February 3, 2000
G-9000-JIM-00-003

Enclosure(s): GTSTRUDL Program Report Form 2000.01

GTSTRUDL Program Report Form

GPRF No.: 2000.01

Figure 1 Typical Design Response Spectrum Curve with Linear Segments

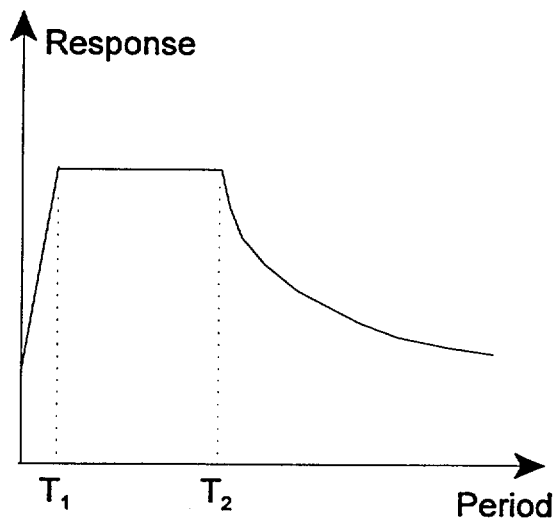
The use of response spectrum files defined by response (acceleration, velocity, displacement) vs period may produce incorrect response spectrum analysis results which may not be readily apparent. The problem is due to the fact that the period input values from the STORE RESPONSE SPECTRUM command are converted to frequency ($f = 1/\text{period}$) before being stored. Then, instead of response spectrum curve interpolation calculations being performed with the input period values, they are actually performed using the converted frequency values. This problem is clearly illustrated by the typical design response spectrum curve shown in Figure 1 below, where the short-period linear portions of the curve can be easily defined by the intersection points of the linear segments of the curve, and where the response and period curve points are input by the STORE RESPONSE SPECTRUM command using the LINEAR scaling option.

Taking the maximum response value as 2.5, the 0-period response as 1.0, $T_1 = 0.15$ sec., and $T_2 = 0.6$ sec., an acceleration-period response spectrum curve of the form shown in Figure 1 could be defined using the following STORE RESPONSE SPECTRUM command:

Taking an input period $T = 0.1$, the corresponding acceleration should obviously be

However, because the period values are inverted prior to storage, the above acceleration-period points are stored as the following acceleration-frequency points:

Maintaining the specified LINEAR-LINEAR relationship, now between acceleration and frequency, the acceleration corresponding to $T = 0.1$ ($f = 10.0$) is now computed as

$$1.0 + \left(\frac{2.5 - 1.0}{6.6667 - 10^{30}} \right) (10.0 - 10^{30}) = 2.5 \quad \text{Eq. 2}$$

The linear relationship between acceleration and period is clearly violated by the conversion and storage of the input period values as frequency values.

After programming modifications were made to correct the processing of response vs period response spectrum curves, subsequent testing revealed that for response spectrum curves of the form illustrated in Figure 1, the greatest differences occurred when the high-participation modes had periods less than T_1 , the trend being that existing response spectrum force results tended to be greater than the corrected results. When the response spectrum curve segment between $0.0 \leq T \leq T_1$ was modeled by only the two extreme points and linear-linear interpolation was specified, old base shear results were observed to be greater than the corrected base shear results on the order of 10%. Similar differences were observed for response spectrum member forces as well. When this response spectrum curve segment was modeled with nine additional points as shown immediately above, and linear-linear interpolation maintained, a difference of .06% was observed. When the structural natural period spectrum was shifted such that the high-participation modes had periods greater than T_1 , the differences between old results and corrected results tended to be much less than 1%.

Work-around

A work-around is to use more points (say 10+) to define all segments of the response-period response spectrum curves as follows:

Note, however, that this is an approximation which merely allows the result of Eq. 1 to be approached as the number of additional points becomes large.
